City of Phoenix

ADDENDUM A **Staff Report: Z-12-18-2** **(LMC Kierland PUD)** June 6, 2018

Paradise Valley Village Planning Committee Meeting Date:	June 4, 2018
Planning Commission Date:	June 7, 2017
Request From:	<u>C-2</u> PCD (2.11 acres) <u>C-2</u> HGT/WVR PCD (2.06 acres)
Request To:	PUD (4.17 acres)
Proposed Use:	LMC Kierland Planned Unit Development to allow a mix of uses including multifamily residential and/or commercial uses
Location:	Approximately 330 feet north of the northeast corner of 71st Street and Tierra Buena Lane
Owner:	Kierland Office Limited Partnership; and Beauty and Barber Supply Institute Inc
Applicant:	Lennar Multifamily Communities (LMC)
Representative:	Nick Wood, Esq., Snell & Wilmer, LLP
Staff Recommendation:	Approval, subject to stipulations

A- Urban Park Area (Date stamped June 6, 2018)

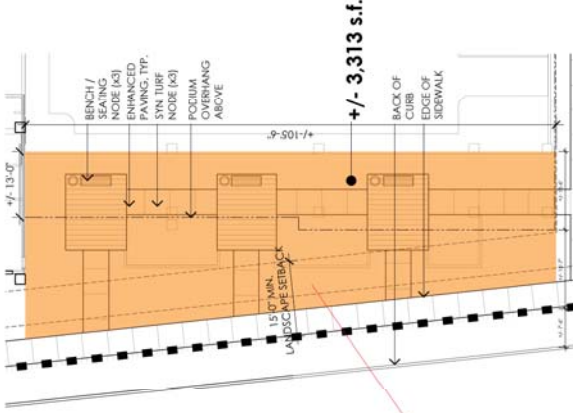
As a result of ongoing dialogue with the area residents the applicant is proposing an update to the frontage standards along 71st Street for the project. The updated frontage includes an additional 5-foot landscape and building setback in order to provide approximately 3,300 square feet of open space that is to be open to the public. The “Urban Park” as identified in Exhibit A, is located at the southwest corner of the site. Exhibit B depicts the modified building setback along the western property line in relation to the building. The urban park will include a shaded seating area, alternative paving and synthetic turf. Stipulations 1.i.6, 1.j and 1.l through s have been modified and/or added to address the inclusion of the urban park element as shown in Exhibit A and Exhibit B date stamped June 6, 2018.

6. Remove and replace with the following: “The non-townhome frontage along 71st Street will ~~not exceed 20 linear feet without being interrupted by a window, or variation in building treatment or design~~ INCLUDE A MINIMUM 3,300 SQUARE FOOT OPEN SPACE AREA, OPEN TO THE PUBLIC FROM DAWN TO DUSK AND INCLUDE THE FOLLOWING FEATURES:
 - MINIMUM OF THREE SEATING AREAS.
 - COMBINATION OF ENHANCED PAVING AND SYNTHETIC TURF. SYNTHETIC TURF CANNOT BE LOCATED WITHIN THE LANDSCAPE SETBACK.

o. EXHIBIT M.9, CONCEPTUAL SITE PLAN: UPDATE AND REPLACE TO DEMONSTRATE 15-FOOT LANDSCAPE AND BUILDING SETBACK. ALSO IDENTIFY THE OPEN SPACE AREA AND NOTE THAT THE AREA SHALL REMAIN OPEN TO THE PUBLIC ALONG 71ST STREET FROM DAWN TO DUSK TO BE CONSISTENT WITH THE EXHIBITS DATE STAMPED JUNE 6, 2018.

URBAN PARK ENLARGEMENT

AVG. SETBACK FROM BACK OF CURB = +/- 35'-4"

AVG. SETBACK FROM PROPERTY LINE = +/- 27'-10"

NEW PROPOSED 15'-0" LANDSCAPE SETBACK

EXHIBIT 'A'

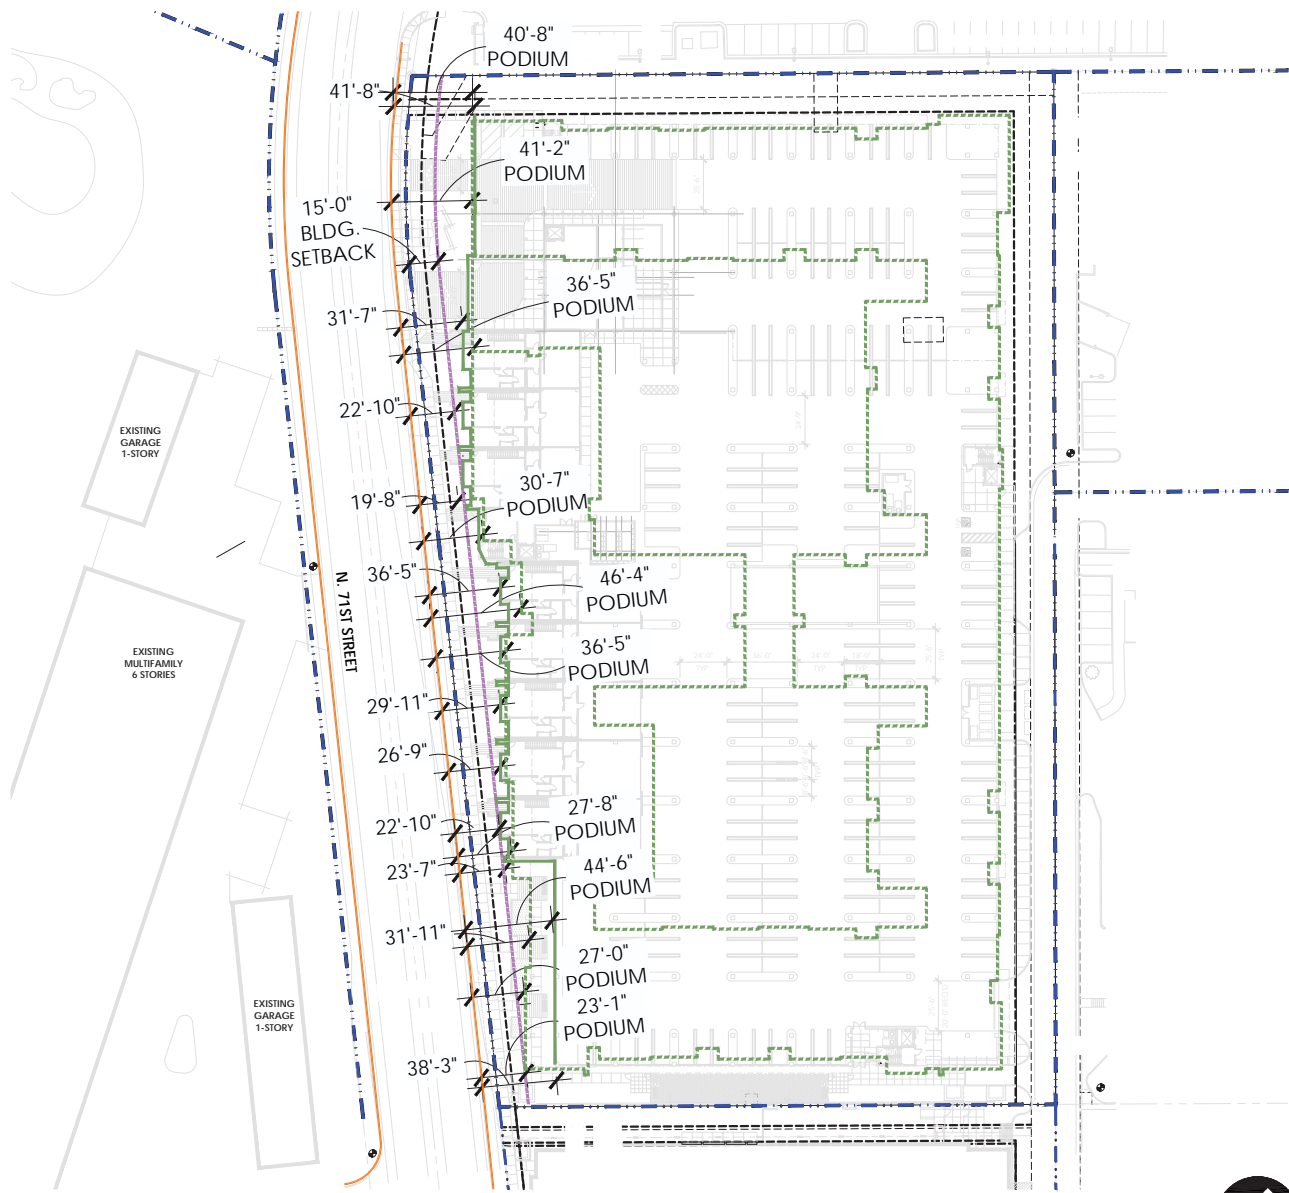
l. PAGE 23, DEVELOPMENT STANDARDS TABLE; FRONT (WEST) BUILDING SETBACK, MODIFY AS NOTED BELOW:

FRONT (WEST)	15-ft 10-ft landscape and 5-ft detached sidewalk
--------------	---

PROPOSED MINIMUM BUILDING SETBACK = 15'-0"
(PROPERTY LINE TO LIMIT OF BUILDBLE AREA)

AVERAGE SETBACK FROM CURB
(BACK OF CURB TO BUILDING FACE)
GROUND FLOOR = +/- 35'-4"
PODIUM ABOVE = +/- 34'-8"

AVERAGE SETBACK FROM PROPERTY LINE
(PROPERTY LINE TO BUILDING FACE - N.I.C. 7'-6"
LANDSCAPE AREA FROM PROPERTY LINE TO
BACK OF CURB)
GROUND FLOOR = 27'-10"
PODIUM ABOVE = 27'-2"
